Requested Action: Approval of a conditional use for the construction of a 360-stall surface parking lot in the M1 (Limited Manufacturing) District.

Madison College is proposing the "Anderson-Hoffman Lot", a 360-stall surface parking lot serving adjacent athletic facilities and the campus as a whole. As proposed, the lot would be constructed in conjunction with a new traffic signal at the intersection of Anderson Street and Hoffman Street, and the driveway entering the lot would be located directly across Hoffman Street.

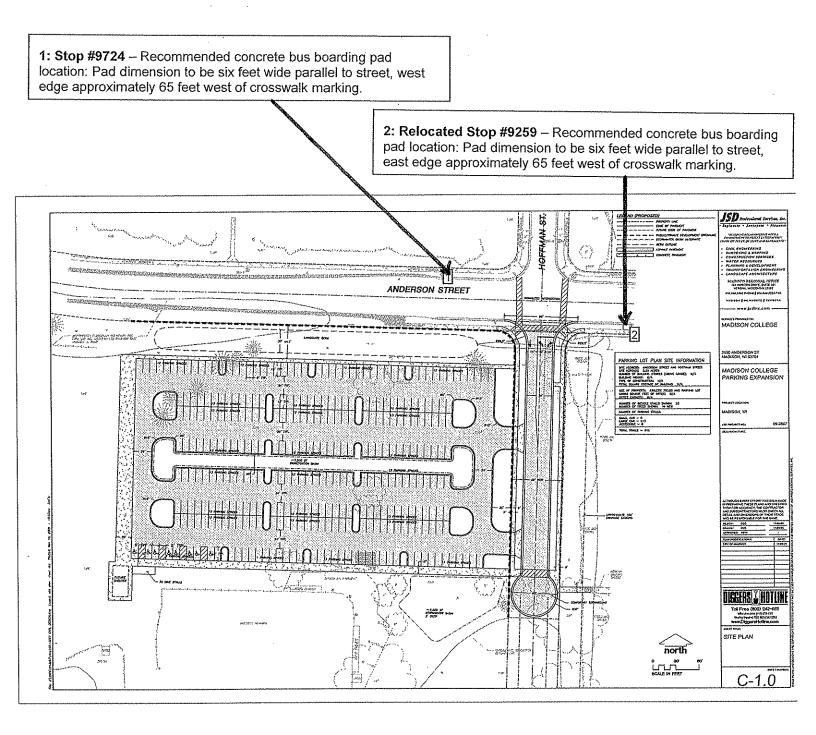
37. Metro Transit operates regular transit service seven days a week along Anderson Street past this location. Stop #9724 is currently located on the north side of Anderson, west of Hoffman. Stop #9259, for trips in the opposite direction, is currently located directly opposite Hoffman in the area of the proposed access drive. Given the reconfiguration of this intersection, Metro Transit recommends that concrete boarding pads for passengers are considered at the existing stop #9724 and relocated site of stop #9259 (shifted east of new driveway). The developer may contact Metro Transit for additional design details if they decide to make this accessibility improvement as part of the overall intersection/parking lot improvement project. (See attachment on following page).

- 4. The applicant shall work with Metro Transit staff to relocate the existing Metro Transit stop on the south side of Anderson Street to a point east of the proposed driveway. A concrete pad in the terrace shall be shown on plans and constructed at this location, and the construction of a second concrete pad is highly encouraged at the corresponding bus stop on the north side of Anderson Street (see also Condition No. 37).
